IEEE P802.15
Wireless Personal Area Networks

| Title | TG3 LB19 comment resolution | |
| Abstract | [This document is a record of comment resolutions for LB19.] | |

Figure 4—PNC handover MSC

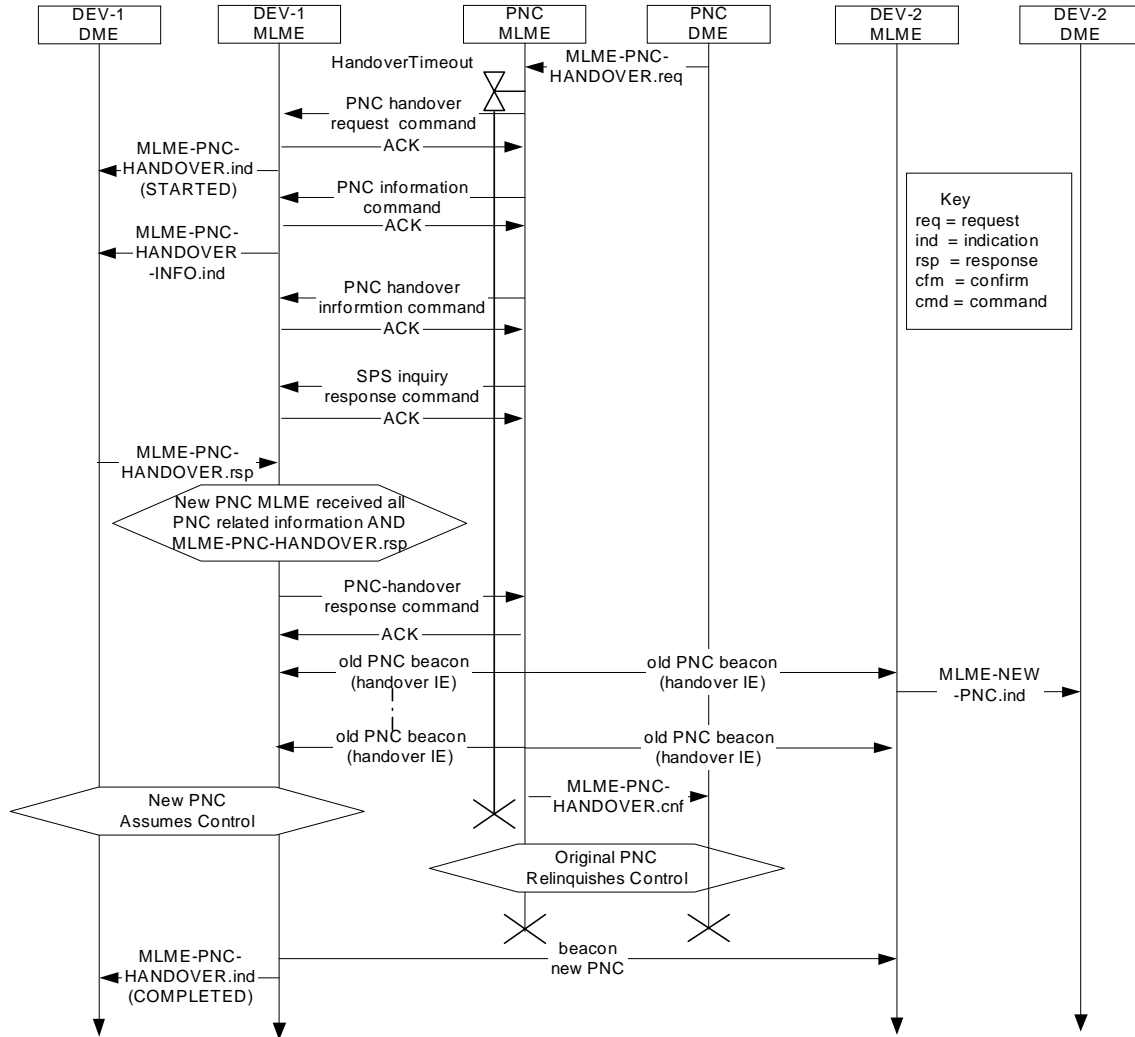
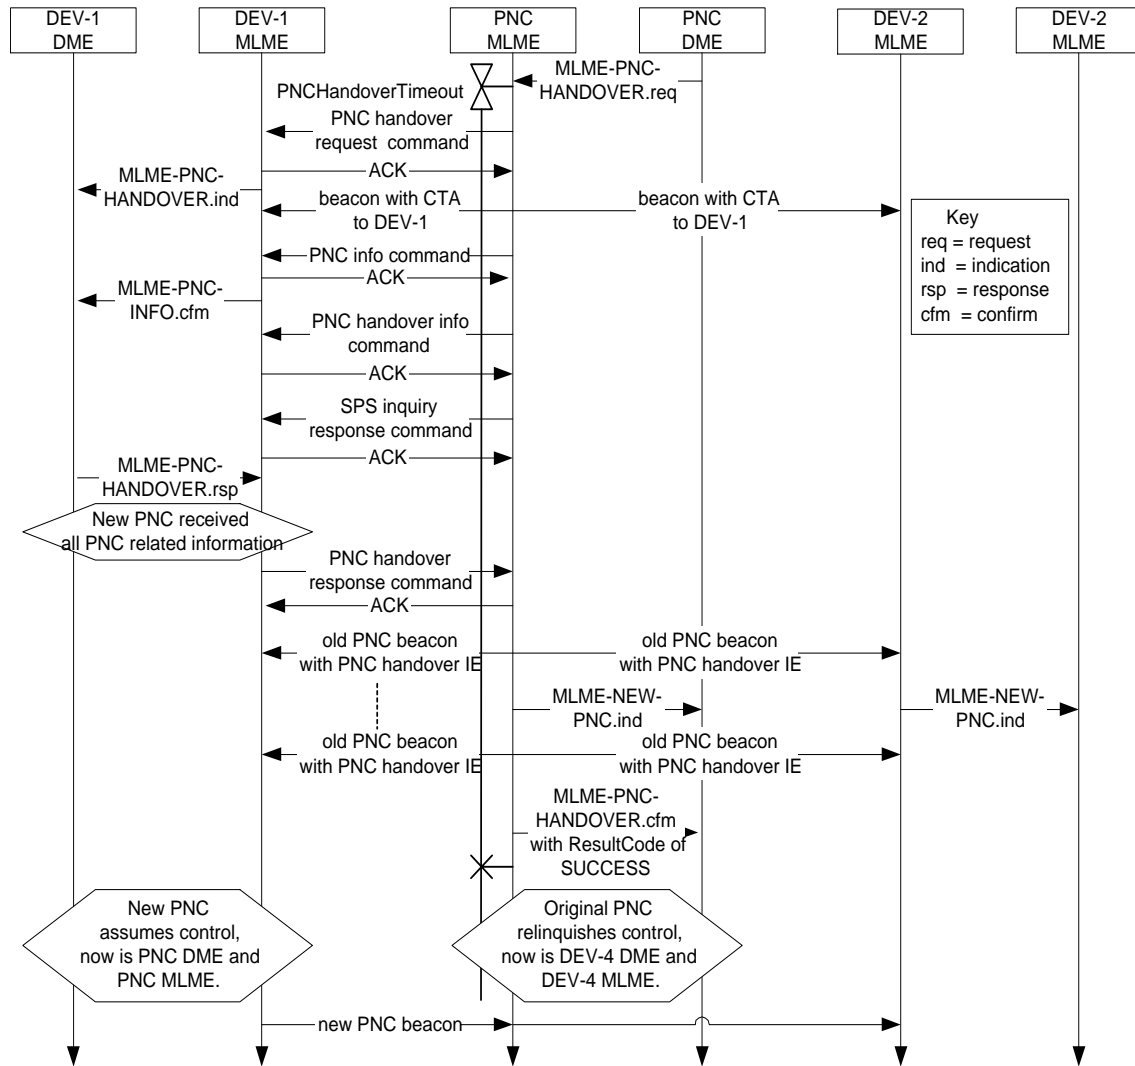
269 (Heberling, TR) - [PNCHndOvr] Some errors in text remain or were introduced after LB17.MSC in Figure 91 is also wrong./KO Text changes for 8.2.3 and ne MSC for Figure 91 are all collected in:02276r7P802-15_TG3-commentsD11_KO.doc, Resolution [03]. **Suggest accept in principle**, “The MSC will be modified as indicated in the resolutions of CID 58 and 232. Make the following text changes: In 6.3.13.4, page 59, line 45, change ‘This primitive informs the originating DME its request for information from the PNC is complete.’ to be ‘This primitive informs the DME that the MLME has received a PNC information command, {xref 7.5.4.2}.’ In 7.5.3.1, page 138, line 20 ‘the number of information records to be transferred using the PNC information command frame(s).’ to be ‘the number of DEV information records, {xref PNC handover info command}, that will be transfered from the old PNC to the new PNC.’ In 8.2.3 PNC Handover, delete page 156, line 8-9, redundant, same text in paragraph below. Add to page 156, line 19, ‘The PNC handover information command shall not be sent if the PNC has indicated in the PNC handover request command that it does not have any CTRBs to transfer.

463 (Gubbi, TR) - Figure-91 is a well done job, but the text needs to supplement some info that can not be expressed in the figure, which is incomplete in the current update to this para. It should be mentioned that these commands shall be sent by PNC even if there is no information present that fits into those commands so that the rx-DEV knows the exact end of the transaction. For example, what if there are no DEVs in power save mode. Still the SPS-inquiry-response-command shall be sent by PNC. It should be mentioned that the three commands in Figure-91 (PNC-info-command, PNC-handover-info-command and SPS-inquiry-response-cmd) shall be sent by PNC even if there is no information present that fits into those commands so that the rx-DEV knows the exact end of the transaction. For example, what if there are no DEVs in power save mode. Still the SPS-inquiry-response-command shall be sent by PNC. **Suggest accept in principle.** "Rather than send the empty commands, the PNC handover request will contain the number of CTRBs and SPS sets that will be transferred. If the number of items is zero, then the old PNC shall not send the command and the new PNC will not expect to receive it. It is not possible for the number of DEVs to be less than 2 (i.e. the old PNC and the new PNC), so the PNC information command will always be sent. This is documented in the resolution of CID 269."

The SPS inquiry response command shall not be sent if the PNC has indicated in the PNC handover request command that it doesn’t have any SPS sets to transfer.’

Add to page 156, line 35, ‘The new PNC shall broadcast its first beacon at the time the beacon would have been sent by the old PNC. This time may vary from the actual time due to clock inaccuracies of old and new PNCs. The new PNC shall start sending beacons with the beacon number counter set to one more than the beacon number of the last beacon that will be sent by the old PNC.’

Add page 156, line 40ff, ‘The PNC shall ensure that the beacon countdown includes at least one system wake beacon and at least aMaxLostBeacons beacons following that system wake beacon. The only exception to this requirement is if the PNC will be shutting down and does not have enough time to to wait for the next system wake beacon to complete the handover process. {Ed. note: This line may be moved to a new 8.1.1 that describes all beacon announcements.’}
